GTS3, Hull

Type 3 Fire Risk Assessment

Prepared for:	Rebecca Franks, Building Safety Manager
Prepared by:	John Askew, Fire Risk Assessor, Holistic Fire Safety
Date Submitted:	26/11/2025
Document Reference:	HFS.HCC.GTS3.FRA.3.0

Photo 17

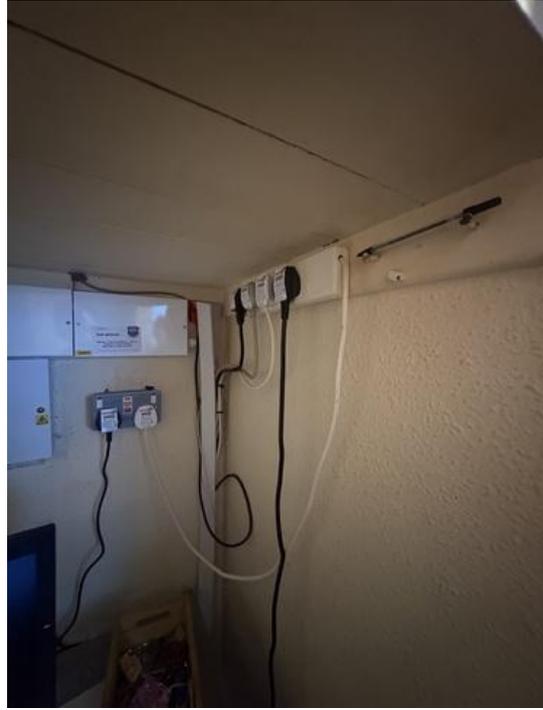
Electrical extension leads were in use in the caretaker's office. Care must be taken not to overload the maximum permitted rating of extension leads. Consideration should be given to removing extension leads and provide additional sockets to supply the equipment in use.

Remove extension leads and provide additional sockets to supply equipment which is in use.

Photo 37

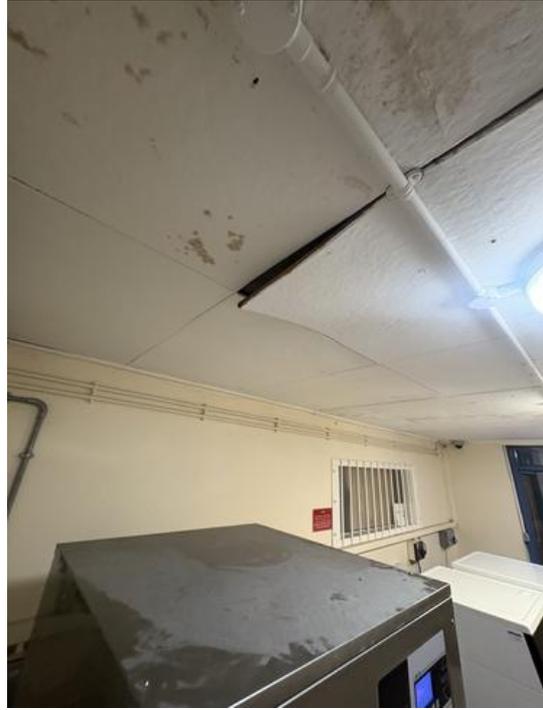
Removal of cement board in resident storage / ancillary areas and above walkways on the ground floor has revealed the installation of insulation. It is understood this was originally installed to provide thermal insulation for first floor accommodation above.

It has been confirmed the insulation present is flammable and should be removed. Any replacement should achieve Class A2-s1, d0 or better.

Remove insulation in areas on the ground floor. Any replacement should achieve Class A2-s1, d0 or better.
